SUNDRY NOTICES AND REPORTS ON WELLS (DO NOT USE THIS FORM FOR PROPOSALS TO DRILL OR TO DEEPEN OR PLUG BACK TO A DIFFERENT RESERVOIR. USE "APPLICATION FOR PERMIT" (FORM C-101) FOR SUCH PROPOSALS.)		WELL API NO. 30-015-53726

Mewbourne Oil Company requests to make the following changes to the APD:

**Full Tilt 18/7 Fed #746H**

## PECOS DISTRICT DRILLING CONDITIONS OF APPROVAL

## Planning Report

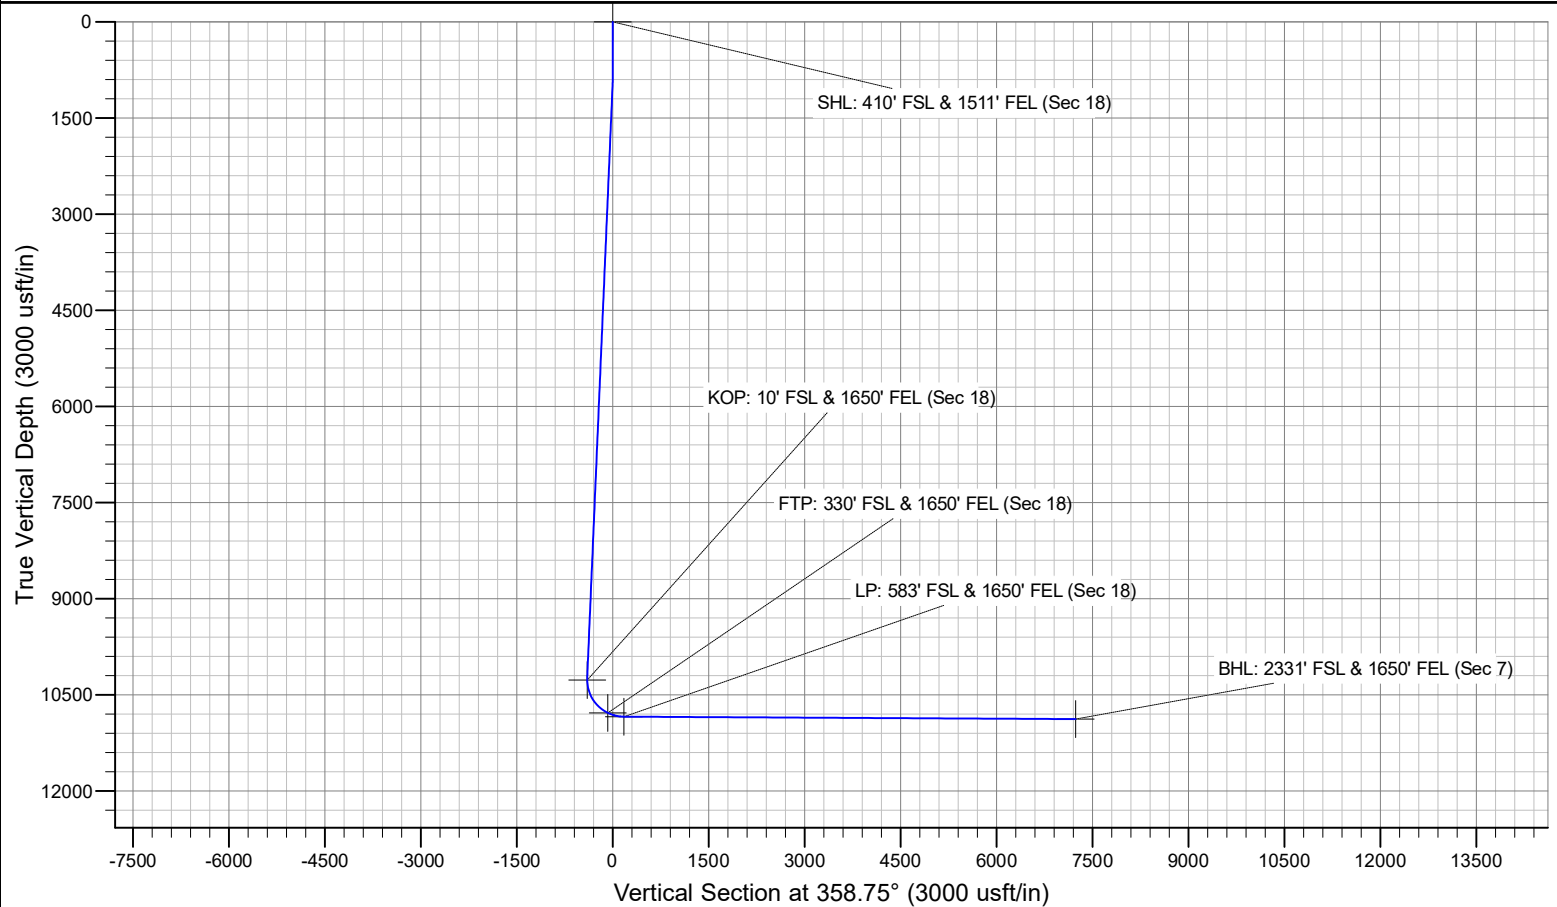
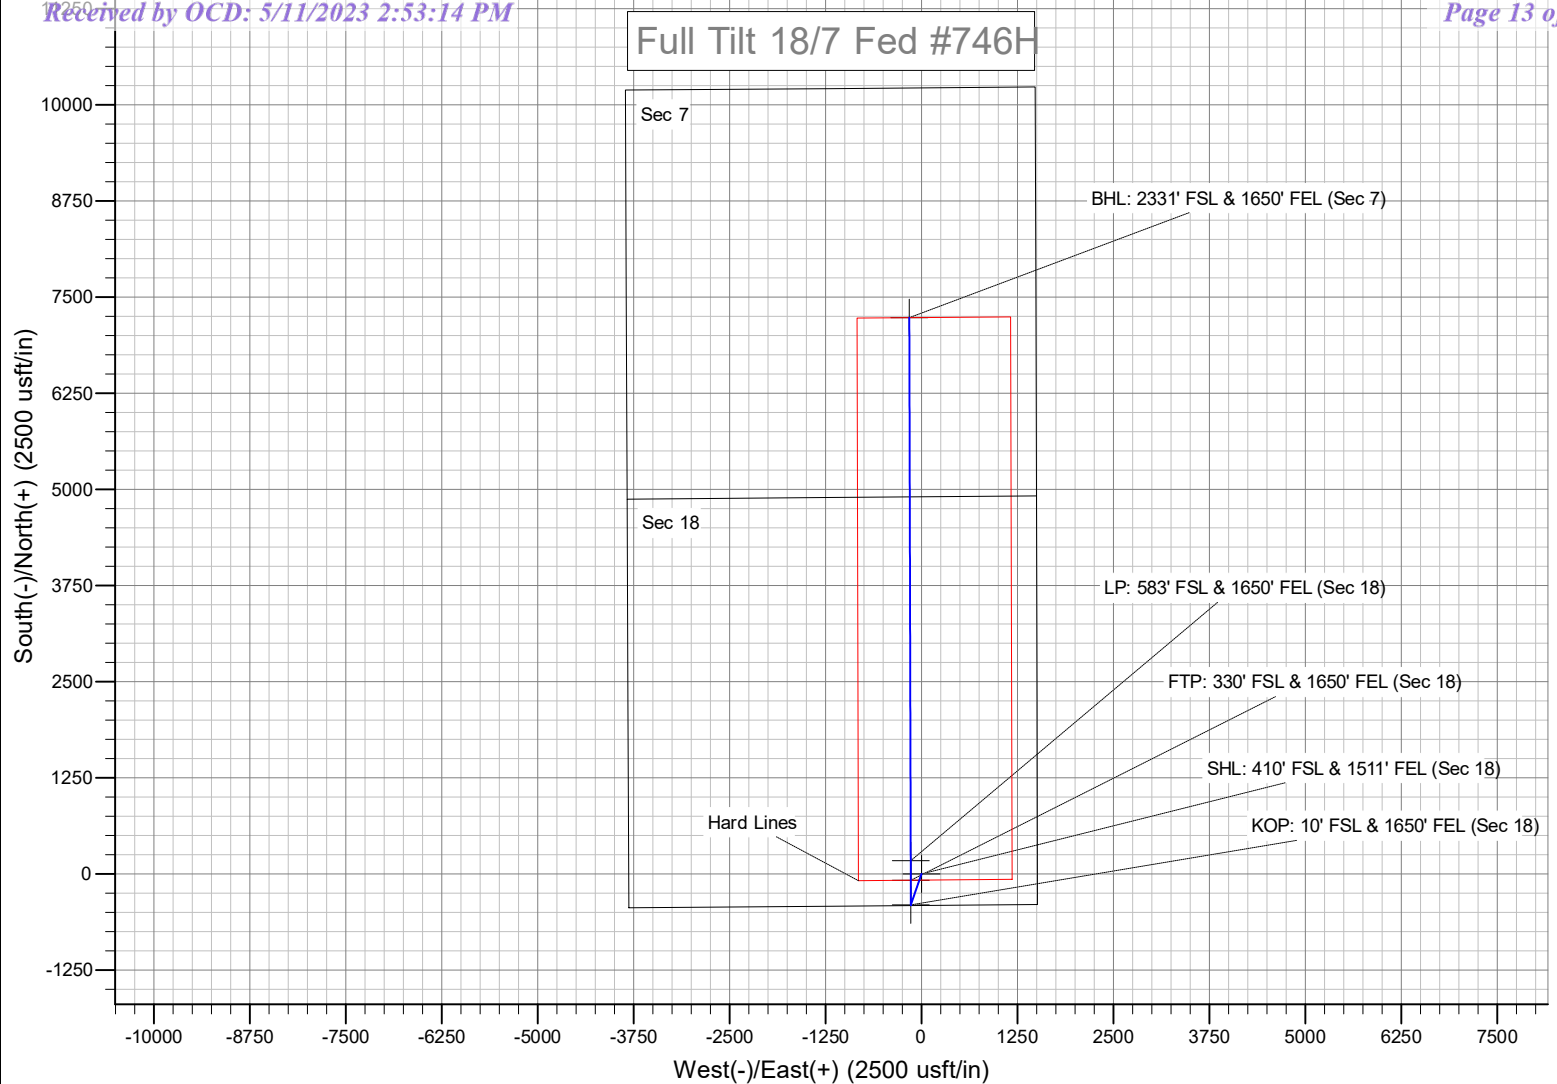
- Change SHL from 254' FSL & 1390' FEL (Sec 18, T26S, R30E) to 410' FSL & 1511' FEL (Sec 18, T26S, R30E). Please see attached updated C102
- Change BHL from 2430' FSL & 1980' FEL (Sec 7, T26S, R30E) to 2331' FSL & 1650' FEL (Sec 7, T26S, R30E). Please see attached updated C102
- Change BOP/BOPE from 10M rating to 5M rating
- Change Casing/Cement/Mud program
- Please see attached drilling program and other documentation referencing design changes and data that corresponds to said procedural alterations.
